Rycroft 730S Substation Expansion Project

August 11, 2020

Alberta Utilities Commission

Decision 25181-D01-2020

Figure 1. Proposed site layout for Rycroft 730S Substation alteration⁴

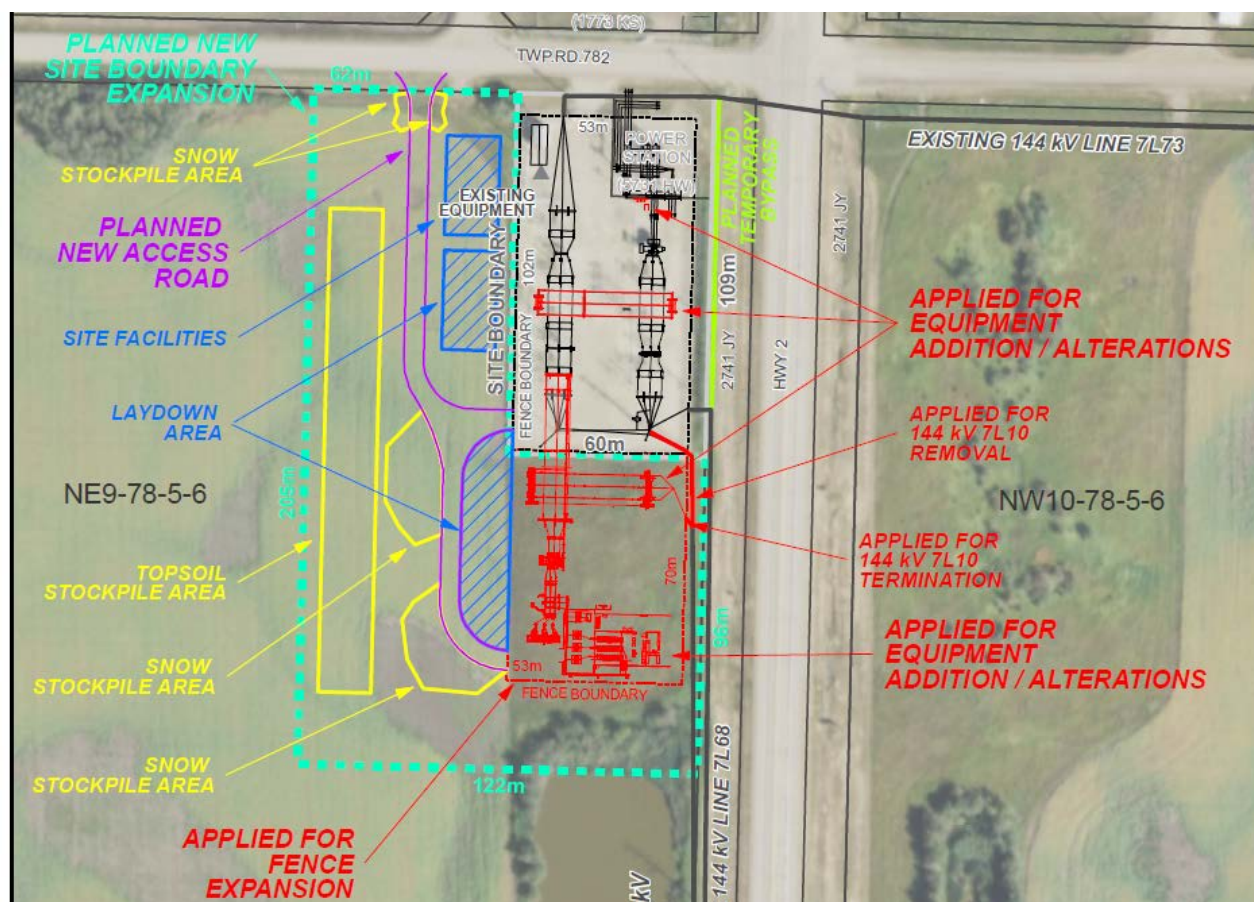
14. ATCO Electric submitted that the expansion area is required to accommodate a new access road, on-site top soil storage, snow storage, and operational workspaces. It stated while it is possible to alter the design to change the expansion area, such changes must be weighed against the prudence of expenditures, engineering constraints, the operational needs of the project, and the ability to operate the substation in a safe and efficient manner. ATCO Electric submitted that the total expansion area is necessary to construct, operate and maintain the substation in a safe and efficient manner and that it did not propose the area simply as a matter of convenience.

16. ATCO Electric estimated the reduction of farmable land resulting from the proposed site expansion to be approximately 4.5 acres and submitted that the expanded site was consistent in size with comparable sites of this nature. ATCO Electric added that some of the expansion land is not currently farmed due to access limitations of the farming equipment. ATCO Electric stated that the landowner would be entitled to compensation for the loss of the land and crops. ATCO Electric submitted that it was open to allowing the Woronuks to farm some unused portions of the expansion area on an annual basis, however, it stated that only preliminary discussions about that had taken place.

18. ATCO Electric submitted that snow stockpile areas were required in the expansion area and it proposed two locations. ATCO Electric disagreed with the Woronuks that snow cleared from the access road could be stored in the adjacent ditches. It added that snow cleared from the existing and expanded substation areas would also need to be stored and consolidating the stockpile into a single area would not reduce the total area required.

21. Dennis Woronuk stated that he has owned the subject lands for 43 years and the lands are currently cultivated by the Woronuks. The Woronuks raised concerns with the size of the proposed expansion area that ATCO Electric requested to take on a permanent basis. The Woronuks stated that ATCO Electric has not provided sufficient justification for the amount of land that it states it requires for construction, operation and maintenance. The Woronuks also submitted that ATCO Electric is requesting a much larger expansion area than what was contemplated in the NID application.

30. The Commission finds that the proposed expansion area, as amended by ATCO Electric in its June 5, 2020 submission, is reasonably required to construct and operate the expanded Rycroft substation, and the resulting site footprint is consistent with similar facilities located on cultivated land. The Commission finds that an access road, stockpile areas, laydown areas and site facilities are required to better ensure the safe and efficient construction, operation, and maintenance of the expanded substation. The Commission also finds that ATCO Electric has provided sufficient justification for the proposed expansion area that accounts for its reclamation obligations and avoids or minimizes potential impacts on nearby sensitive environmental features such as the dugout south of the substation.

Figure 2. Woronuks' proposed site plan¹⁰

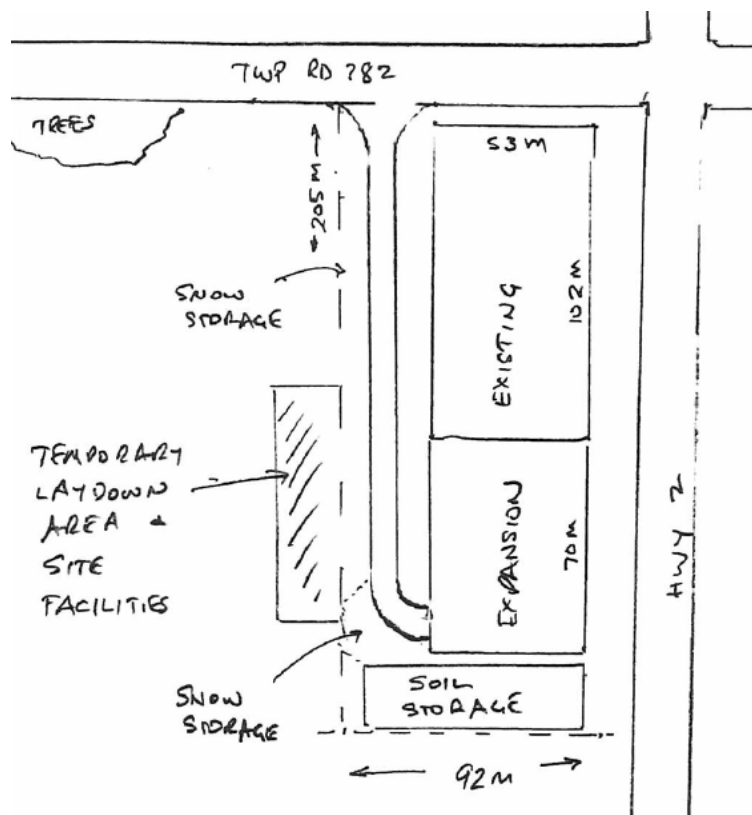
19. While ATCO Electric opposed the late submission of the Woronuks' proposed site plan, it addressed the plan in its reply argument. ATCO Electric submitted that the hand-drawn plan was not accurately surveyed or scaled, and did not provide adequate space for the permanent operational workspaces that were required. ATCO Electric also submitted that soil storage could not be accommodated south of the expanded substation's fenceline because that area is needed for ground grid and surface water management. ATCO Electric also questioned whether the size of the suggested topsoil and snow storage areas were adequate because there were no dimensions on the Woronuks' site plan and it did not seem to account for the amount of clearing needed or the presence of existing trees.

25. The Woronuks submitted a proposed site plan in their written argument that would reduce the amount of land required. The Woronuks proposed to relocate the soil storage to an area south of the substation expansion. They stated that the land slopes to the south from the existing substation, which would allow for higher and wider soil stockpiles. The Woronuks proposed that the snow stockpile be located to the south of the expansion area as well as in the ditches on the sides of the access road. The Woronuks also proposed to locate a temporary laydown area and a temporary area for site facilities needed during construction to the west of the expansion area, as shown in Figure 2.

28. In regard to ATCO Electric's concerns about the Woronuks' late submission of their proposed site plan, the Commission notes that the plan is hand-drawn and more conceptual than technical in nature, and the site features depicted within it are consistent with the Woronuks' oral and written evidence in the proceeding. ATCO Electric also had an opportunity to provide written comments on the plan in its reply argument. The Commission therefore allows the plan to remain on the record as part of the written argument filed by the Woronuks.
